# MARTIN COUNTY

May 28, 2020

Review of the Draft RECOVER Northern  
Estuaries Performance Measures: Salinity  
Envelope and Hydrologic Criteria

Figure 1. Daily freshwater discharge (cfs) to SLE from all measured sources, including (Lake O.) vs. daily averaged salinity (ppt) measured by the LOBO station at Saint Lucie Inlet.

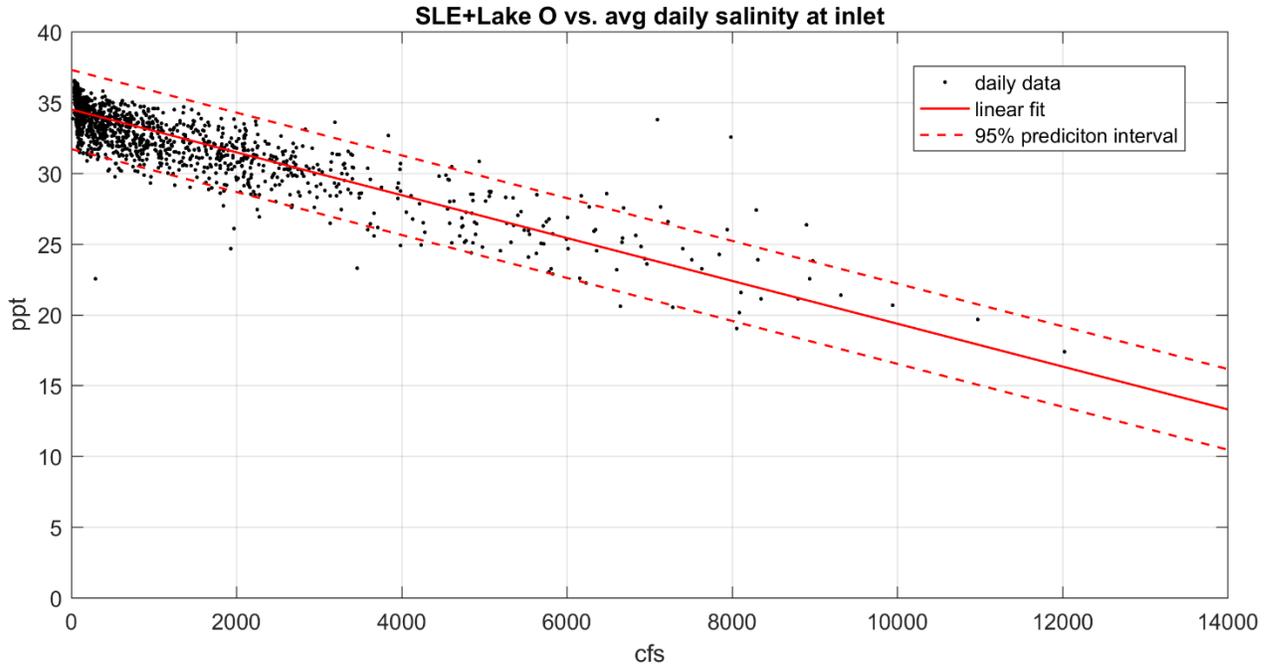
The 4000 cfs limit for damaging flows to the IRL and offshore areas is based on an analysis of salinity data from the FAU Harbor Branch LOBO monitoring network (spanning 2015 to present) and daily flows reported by SFWMD at structures that discharge to the SLE (S-80, S-48, S-49 and S-71). Figures 1 and 2 present a comparison of daily average salinity data to total daily flow into the St. Lucie Estuary from all measured sources over the last several years. The dashed lines show the prediction interval (PI) of the linear fit of the data, and contain 95% of the measured values. As a ‘first cut’ we recommend that the lower salinity range represented by the PI would be appropriate limits for “high flow” model scenarios.

Figure 2. Daily freshwater discharge (cfs) to SLE from all measured sources, including (Lake O.)

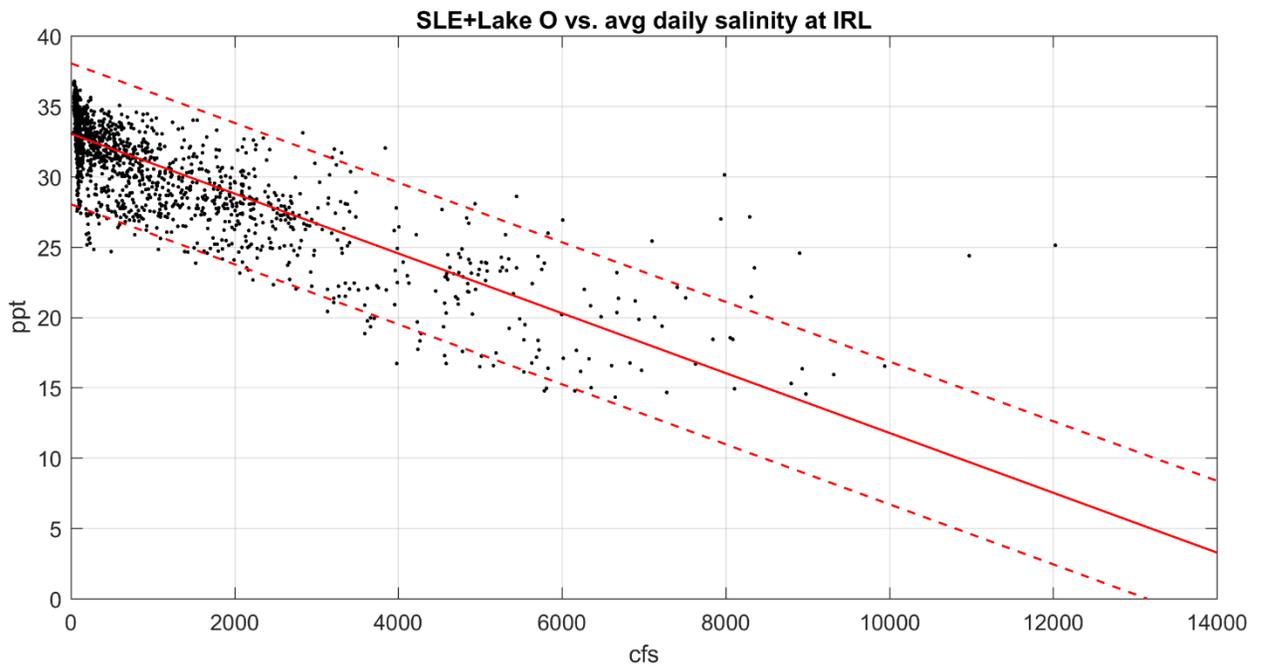
From the stand-point of protecting various resources, the following limits are recommended: seagrass in the Indian River Lagoon less than 20 ppt salinity on average and offshore coral in the Atlantic Ocean off the St. Lucie Inlet station of less than 25 ppt salinity on average. It is assumed that flows that would drop average salinity values below these levels would be damaging to ecological resources in the region seaward of the St. Lucie Estuary. Both criteria indicate a maximum total freshwater inflow of 4,000 cfs to ensure protection of the lower

Figure 3. 14-day running average of total freshwater flow input to SLE, including groundwater and discharges from Lake O, for the period between July 1999 and March 2020.

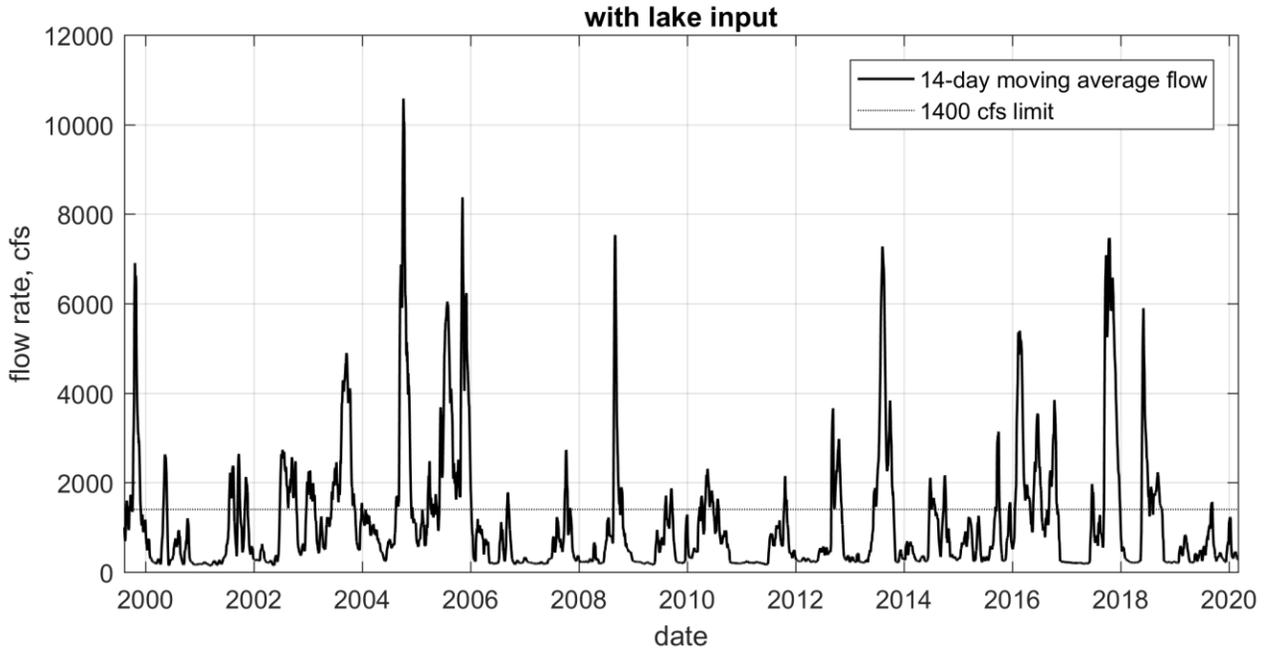
The 14-day running average of the total measured freshwater flow to the SLE with and without Lake O discharges are presented in Figures 3 and 4, respectively. In these plots, the RECOVER flow envelope maximum for the updated optimum salinity envelope (1400 cfs) is plotted with the daily running 14-day average flow. A 14-day running average was used in this comparison to be consistent with the averaging method used in the RECOVER analysis to determine the relative performance of the modeled scenarios. To reiterate the point made previously, the averaging methodology utilized in the RECOVER analysis is not clearly defined nor consistently described, but a 14-day running average for these plots was used.

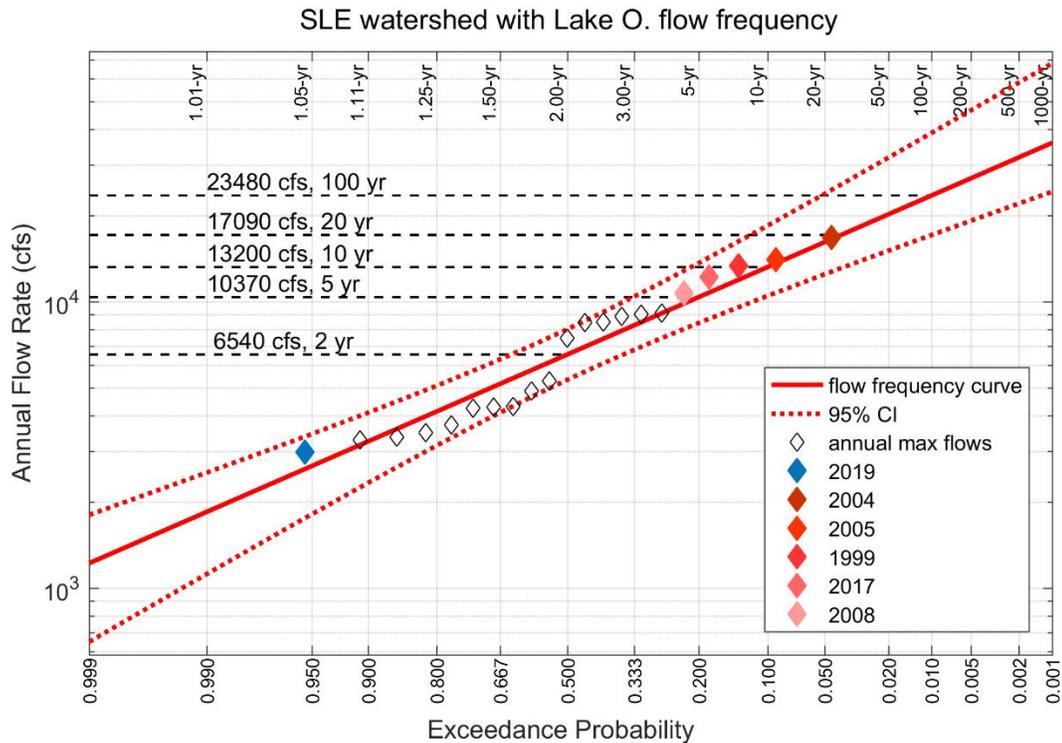
In addition to the above statistics, an evaluation of long-term freshwater flow exceedance also was developed. Figure 5 represents the total daily flow exceedance for all freshwater entering the St. Lucie Estuary from both watersheds and Lake Okeechobee. At present, the flows exceeded on an annual basis are in excess of the targeted salinity envelope presented in the RECOVER document. In addition, the watershed flows without contributions from the Lake also exceed the target envelope, based on average annual flow values. Therefore, it is anticipated that future RECOVER efforts will need to prioritize reducing discharges from Lake Okeechobee, as well as ‘unnatural’ discharges from the expanded/channelized watershed, to effectively restore the St. Lucie Estuary and surrounding waterbodies.

It should be noted that high flow conditions (e.g. the 20-year events) can have freshwater inflow values in excess of 10-times the value that will be ecologically damaging to the upper estuarine waters. The influence of these frequent high sustained freshwater inflows into the estuary also should be considered as part of the RECOVER evaluation.
